RFI Ref.	Title	Associated Atkins Document	Date Raised	Complete	Comments
155	Review of Atkins' Site Wide Open Space Validation Report for Monitor Phase 39	Atkins' Validation Report for Phase 39 (ref. 5041216-REM-RPT-1340)	August 2015	Yes	Updated validation report received in October 2015

DRAWING TITLE
MONITOR PHASE 39

Contract Name: Coed Darcy Monitor RFI No:
Contract Number: GNP/NJR/13773-2 Date Raised: 21 August 2015
Subject: Review of Atkins' Site Wide Open Space Validation Report for Monitor Phase 39
To: Michelle Lee Atkins
Cc: Mike Poland Atkins
From: Rhys Mander AECOM

DRAWING NO 5041216-REM-DWG-1661	REV P5
------------------------------------	-----------

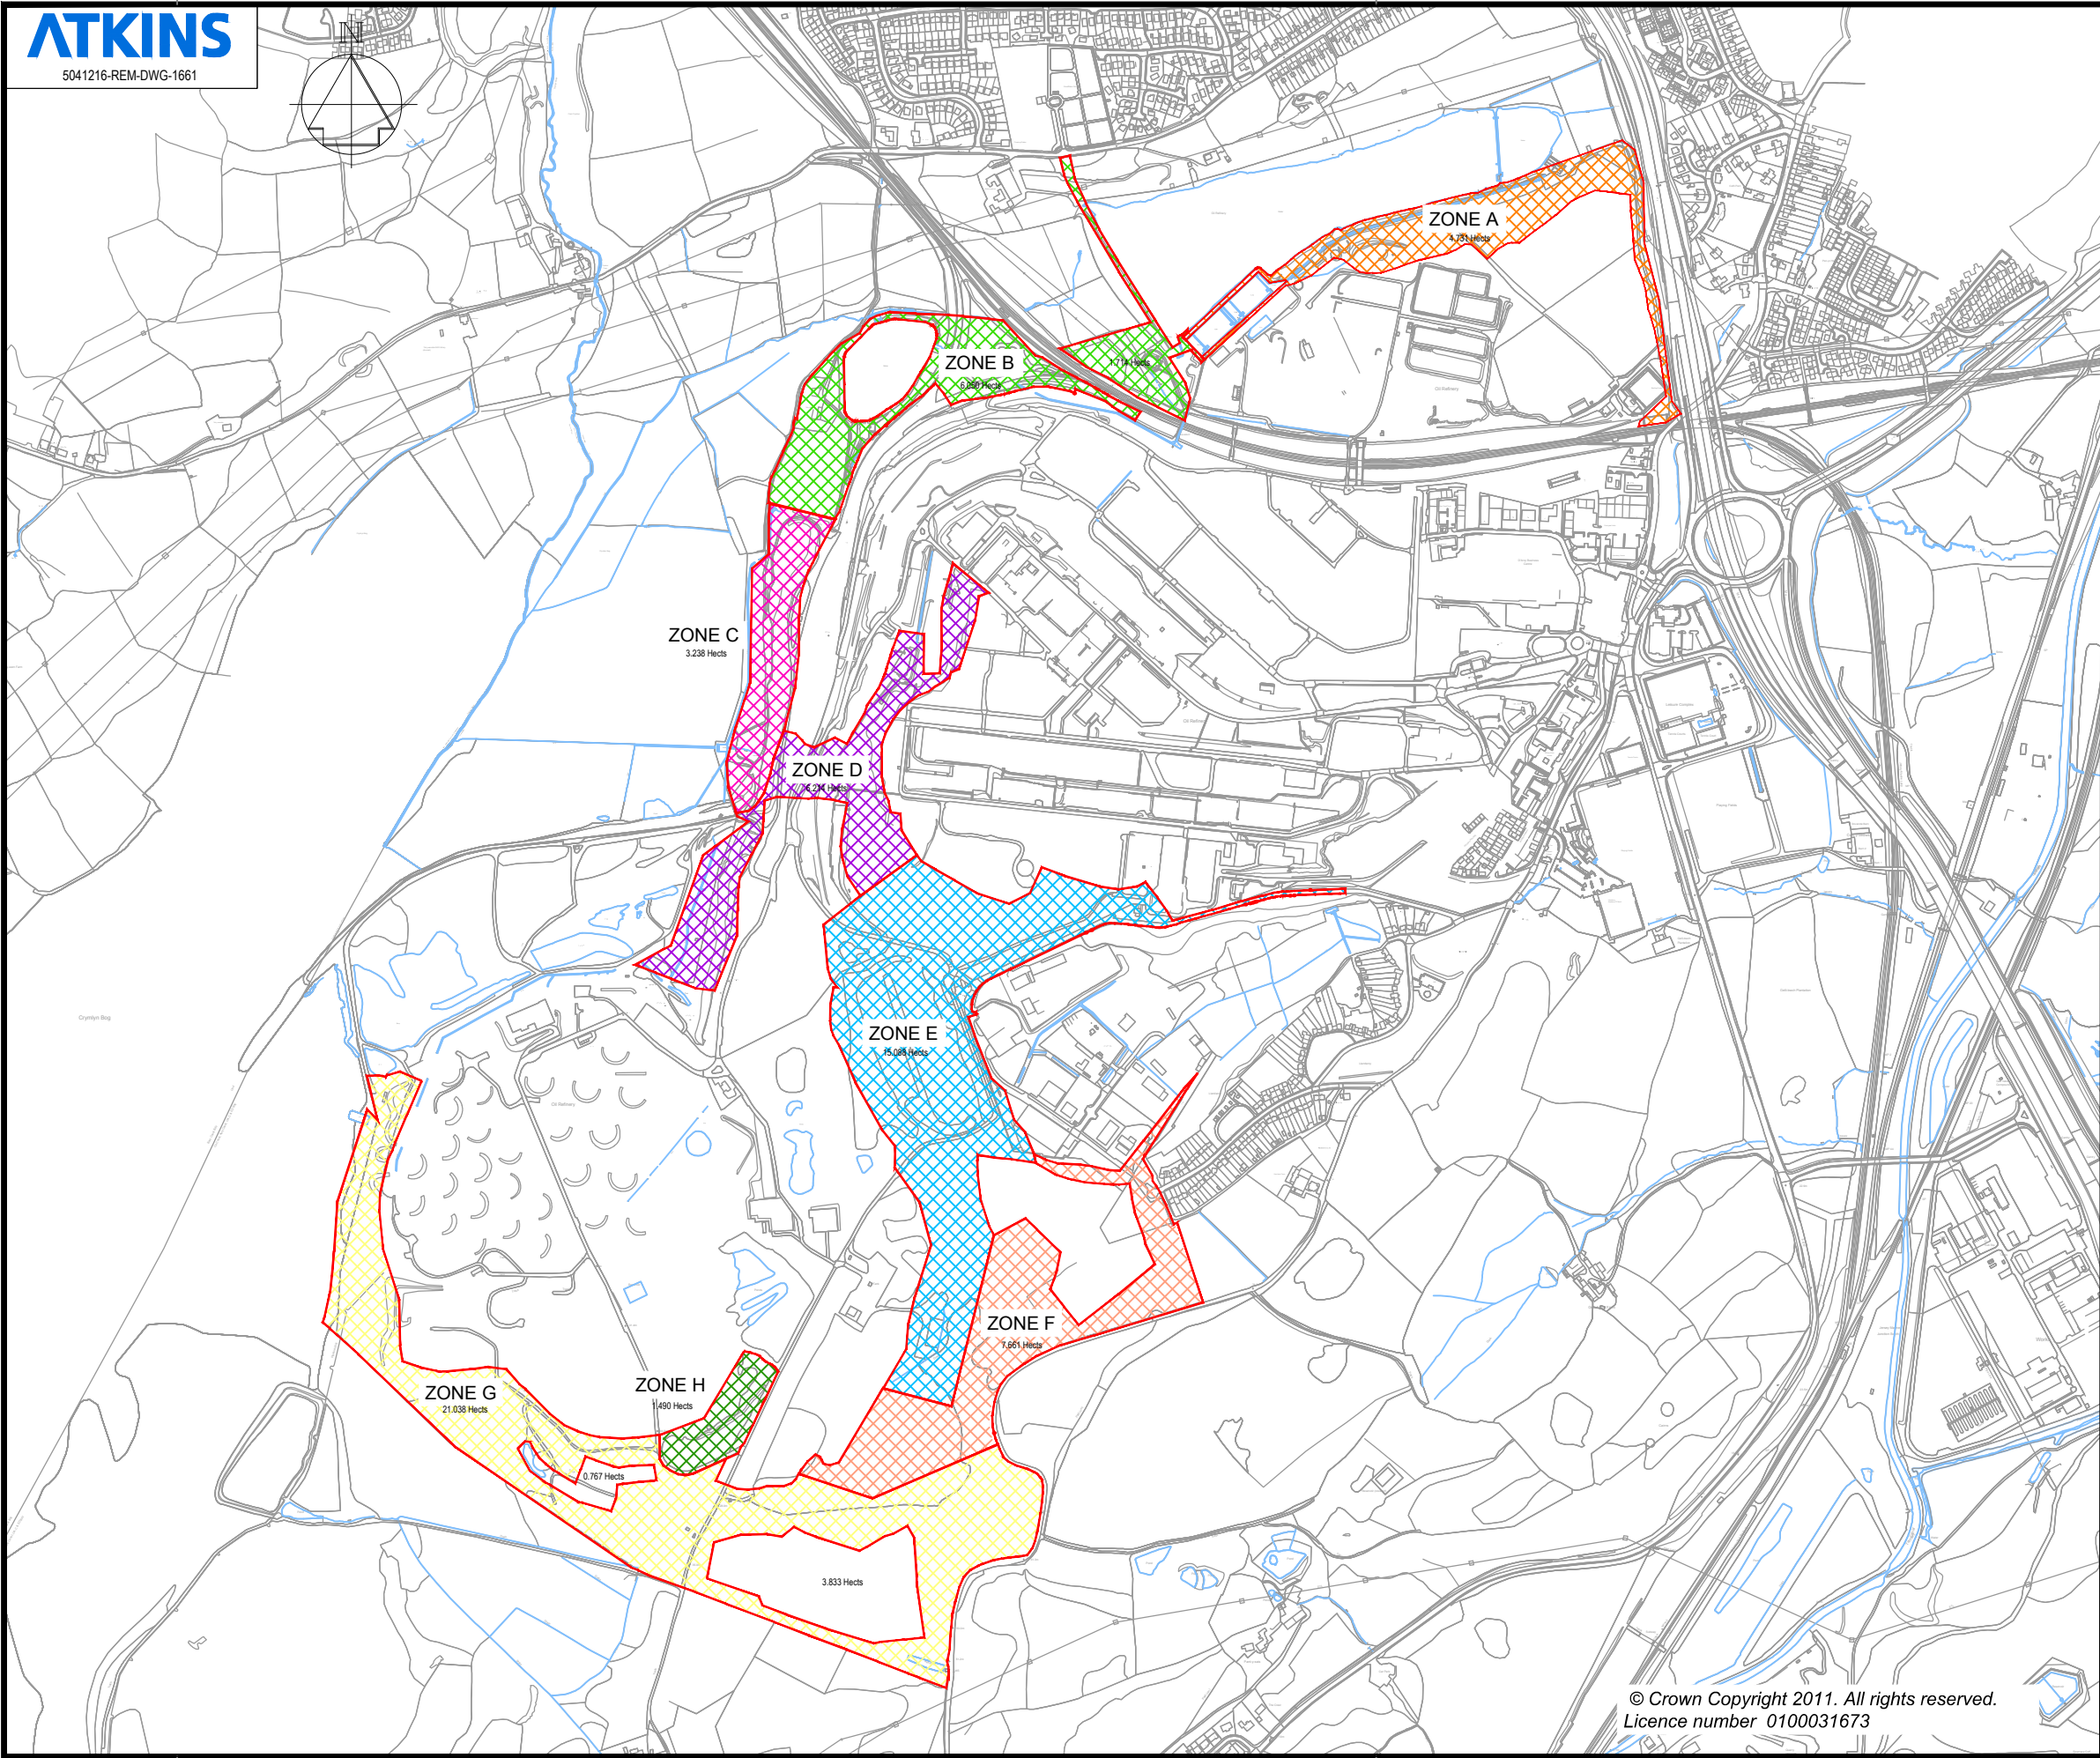
- With reference to drawing no. 5041216-REM-DWG-1661 it is suggested that Zone A should be extended to include the wooded area to the north of North Site Reservoir. Whilst this area falls outside of the development boundary, it falls within the property boundary as defined in the Section 106 Agreement.
- Although just outside the boundary of Zone A, it is suggested that further works are required along the southern edge of East Bay, including where the former separator was broken out. The water here is often scummy and there is various general debris along the banks as shown in the photos provided below.

- With reference to drawing no. 5041216-REM-DWG-1661 it is suggested that Zone B should be extended to include the area to the west of North Site Reservoir between the dam and the railway. It is also suggested that Zone B should include the area to the north of South Site Reservoir, i.e. the triangle of land situated between the northern edge of the reservoir and the railway line. Whilst these areas fall outside of the development boundary, they fall within the property boundary as defined in the Section 106 Agreement.

- With reference to drawing no. 5041216-REM-DWG-1661 it is suggested that the boundary for Zone E should be amended so that it does not include the contractor's yard. From the available aerial photography this area appears to be being used for storage and stockpiling of materials. It is suggested that this area should be omitted from Zone E and dealt with along with the rest of the contractor's yard.
